Draft Final
Operable Unit Carbon Tetrachloride Plume
Remedial Investigation/Feasibility Study
Work Plan
Former Fort Ord, California

October 16, 2002

Harding ESE
A MACTEC COMPANY

PLATE:
8

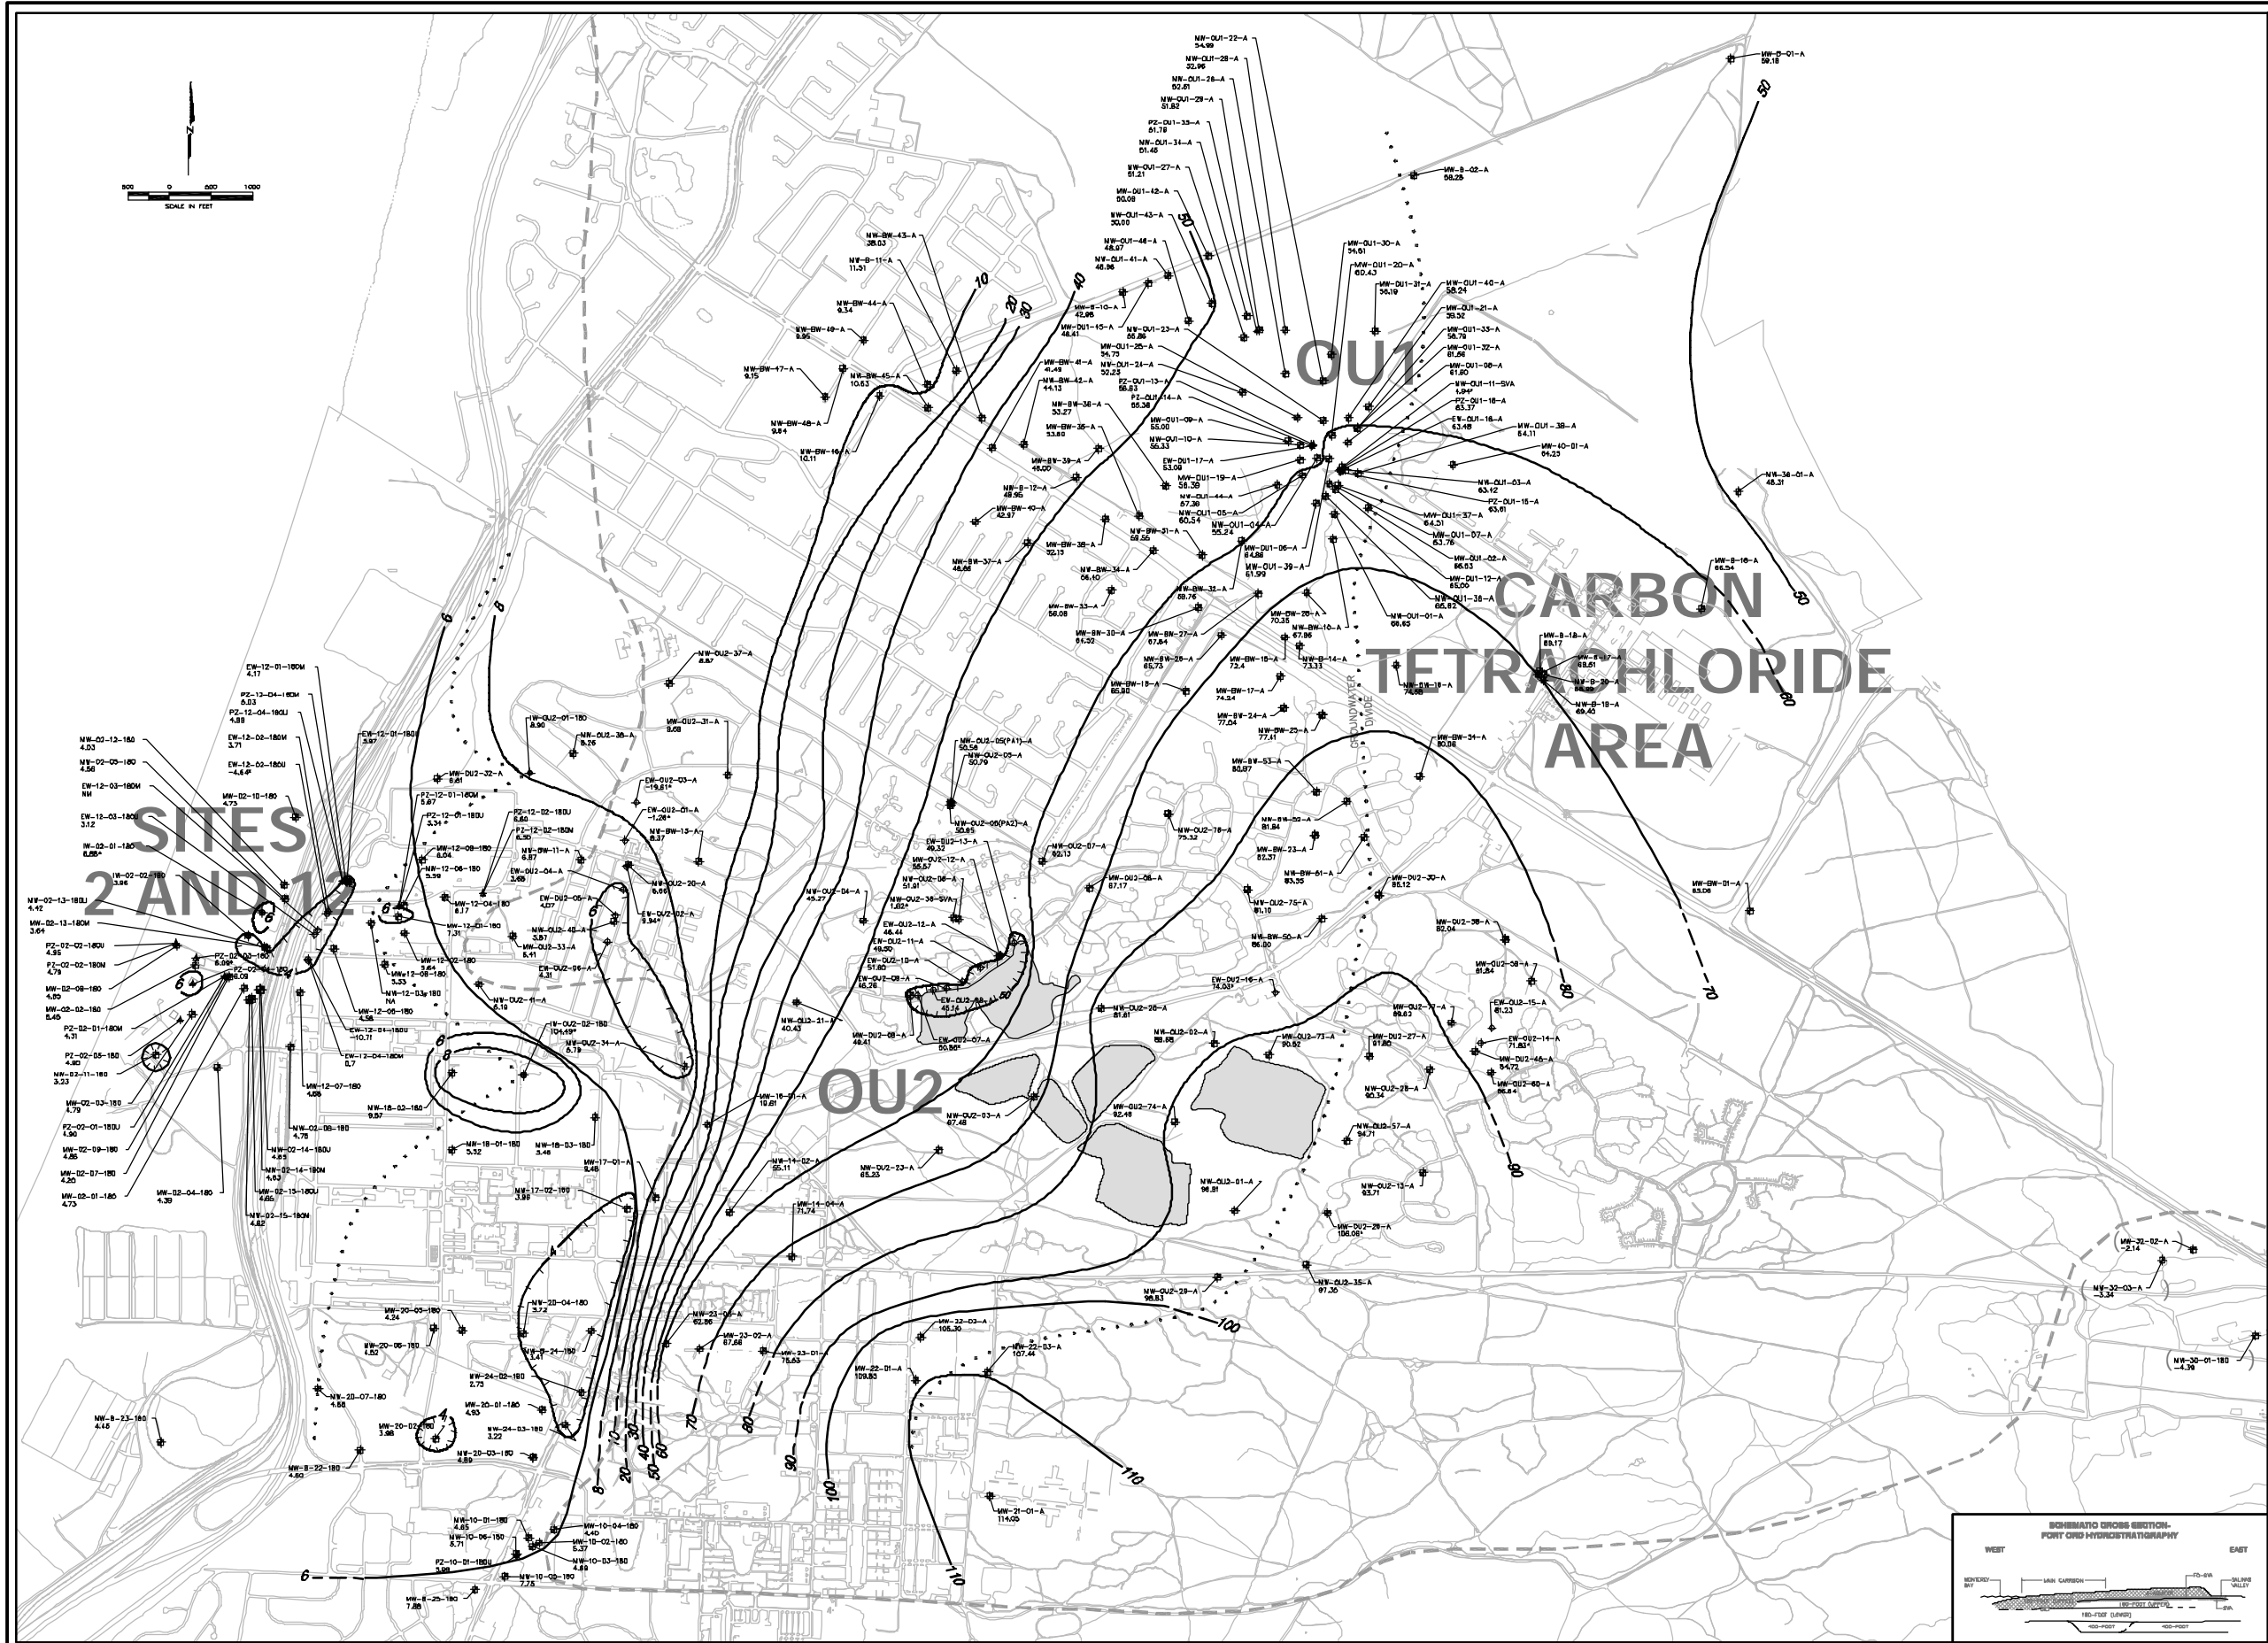
Response: The subtle southern shift in groundwater flow is not apparent at the scale with which Plate 8 was presented; however, we would refer you to the *Draft Final, Carbon Tetrachloride Study Area, Drilling Letter Report – Monitoring Wells MW-BW-43-A through MW-BW-54-A, Former Fort Ord, California*, dated February 6, 2002. Plate 2 of this document illustrates A-Aquifer groundwater elevation contours at a site-specific scale where the subtle southern shift in groundwater flow direction near the toe of the A-Aquifer plume is more apparent. The RI report will include a map similar to this Plate 2 but will include the most current and complete data.

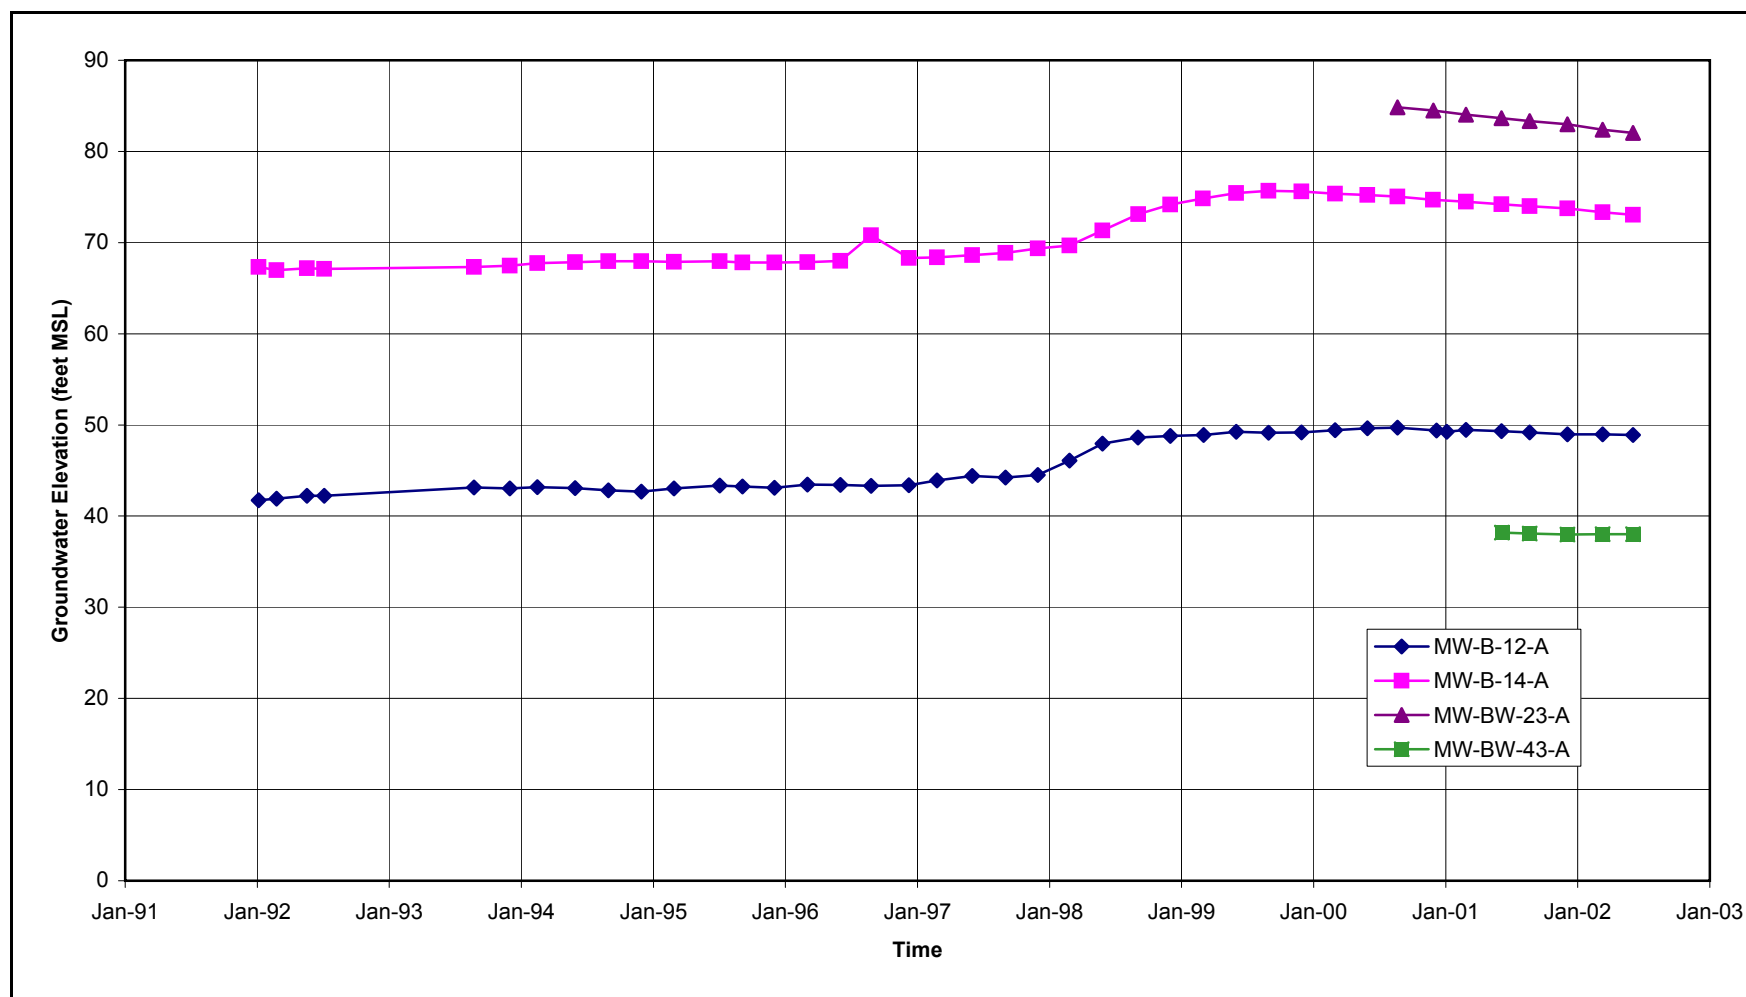
The GSU recommends correction of the text, or an explanation provided for the apparent discrepancy between the text and the hydrograph on Plate 9.

PLATE	10
SHEET:	OF
REVISION NUMBER:	0
DATE:	12/01

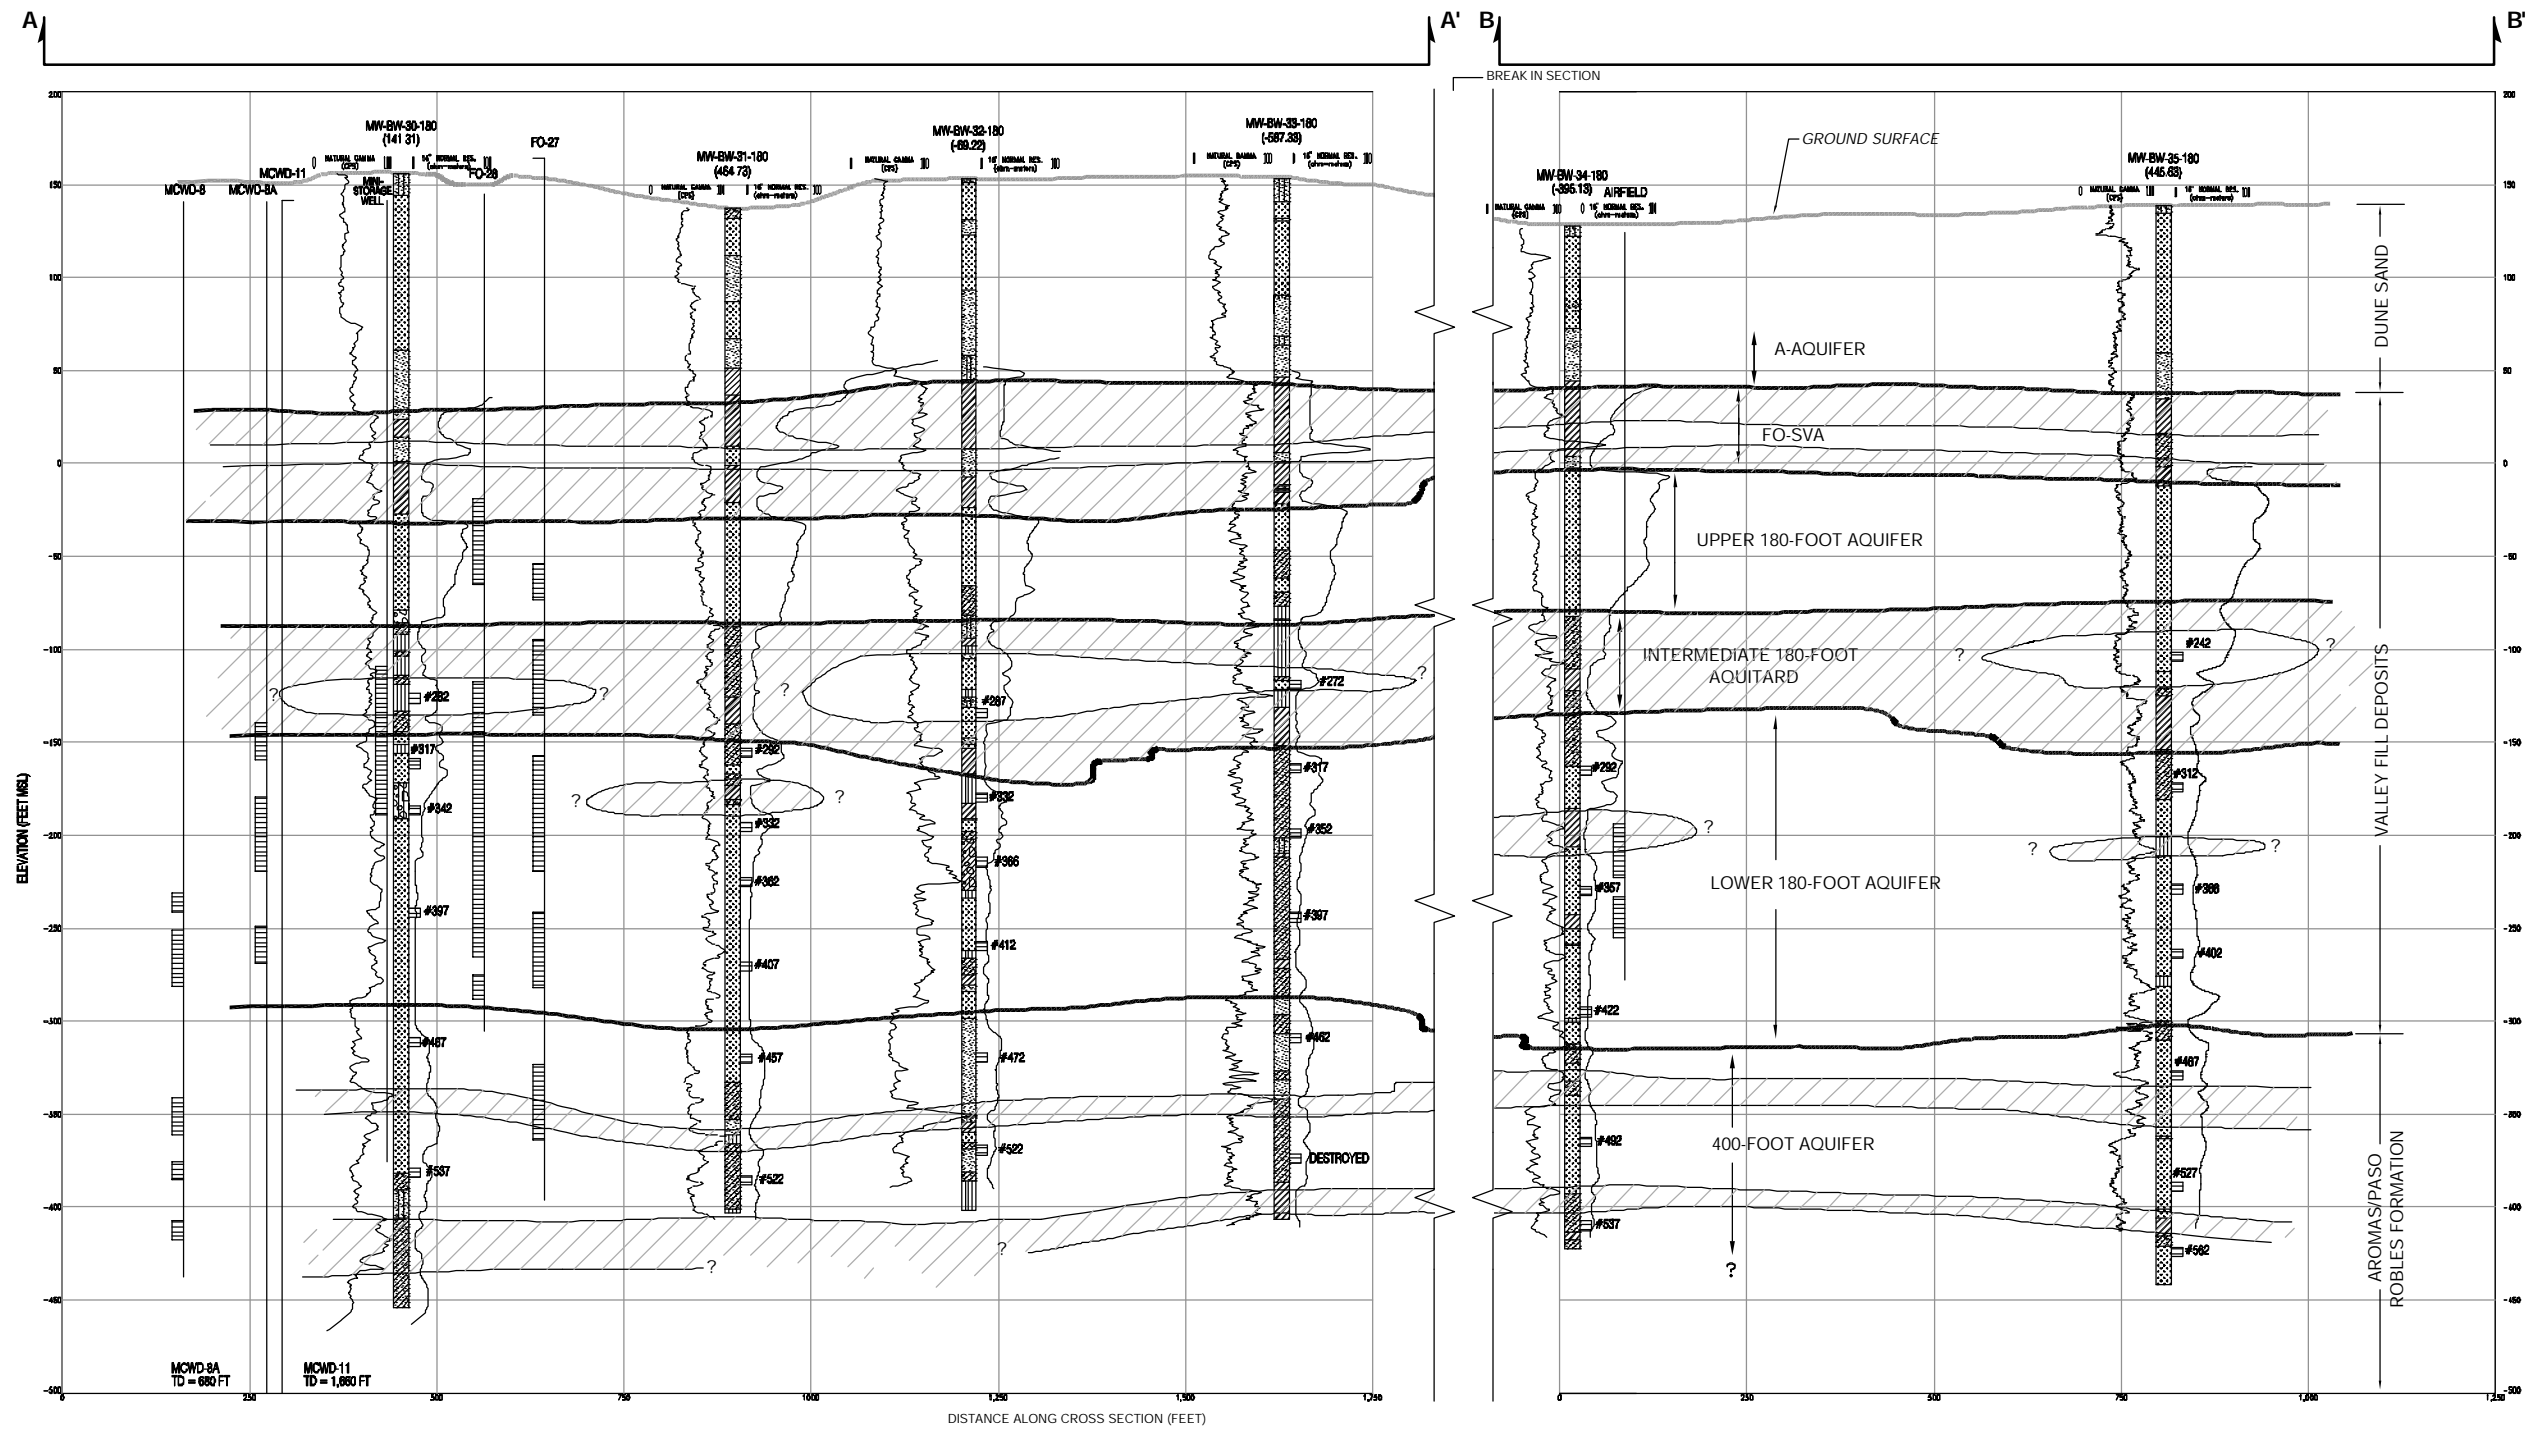
- 1) Page 5, Section 2.4.1, Paragraph 1: Former Fort Ord drinking water supply wells Nos. 26, 27, and 28 are referred here to have been located within the current OU CTP. Later in the Draft OU CTP RI/FS Work Plan these wells are stated as at one time being possible conduits for contaminant flow from the shallow to deep aquifers beneath the Site. However, these wells do not appear on any of the plan-view drawings included with the Work Plan. Wells FO-27 and FO-28 do appear in geologic cross-section A-A' on Plate 10.

20

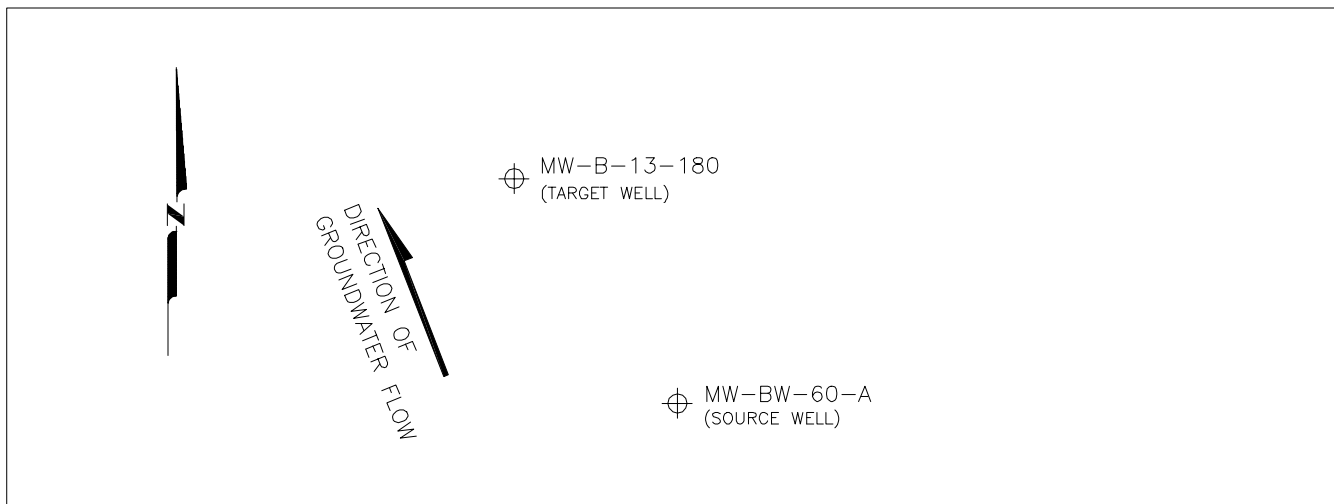
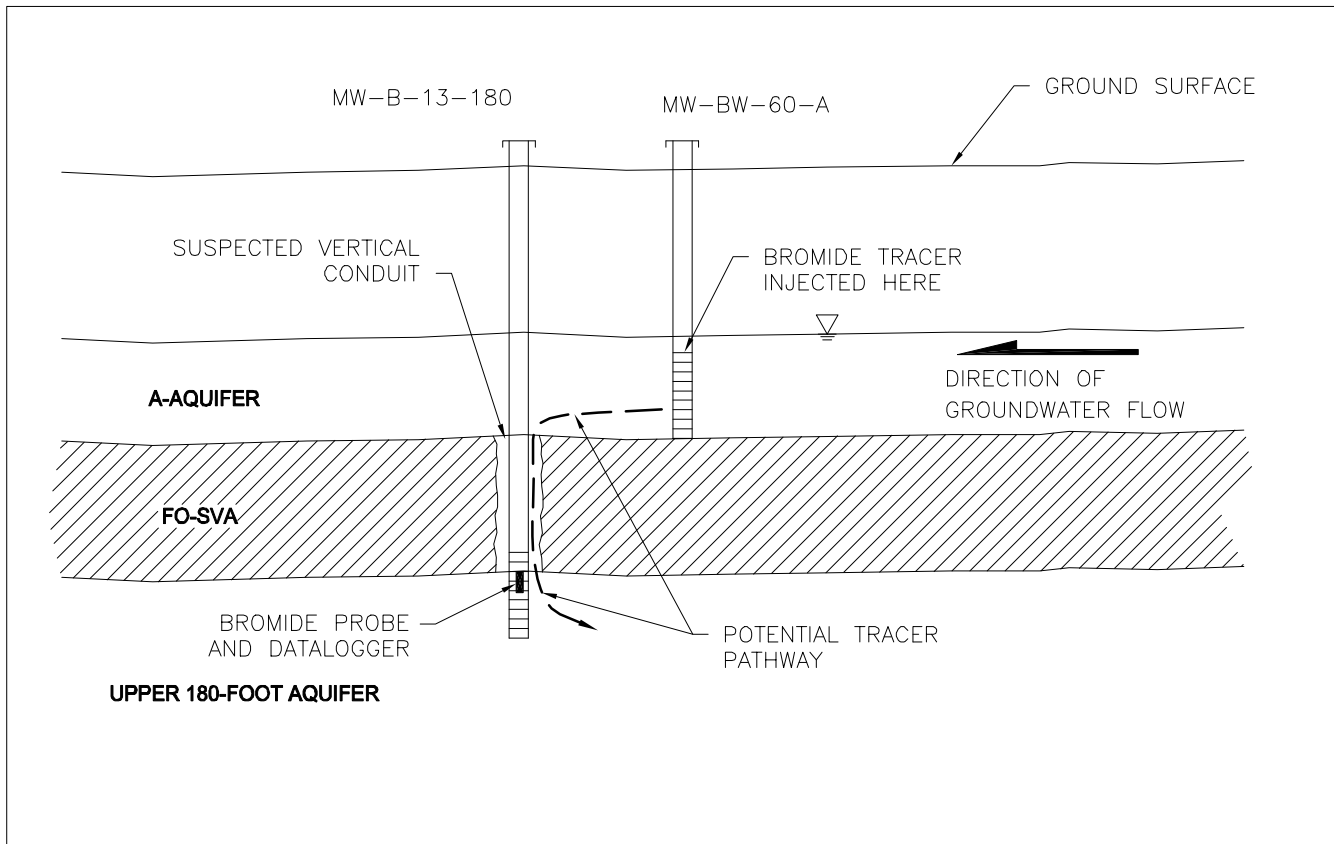
4. *Page 49, Section 4.3:* We support the concept of the proposed tracer test. The report's text does not indicate which well will be used as the tracer source. Our understanding from Plate 20 is that MW-BW-60-A, yet to be installed, has been selected. Please indicate if our understanding is correct and note the selected source well in the report text and its approximate lateral separation from MW-B-13-180.
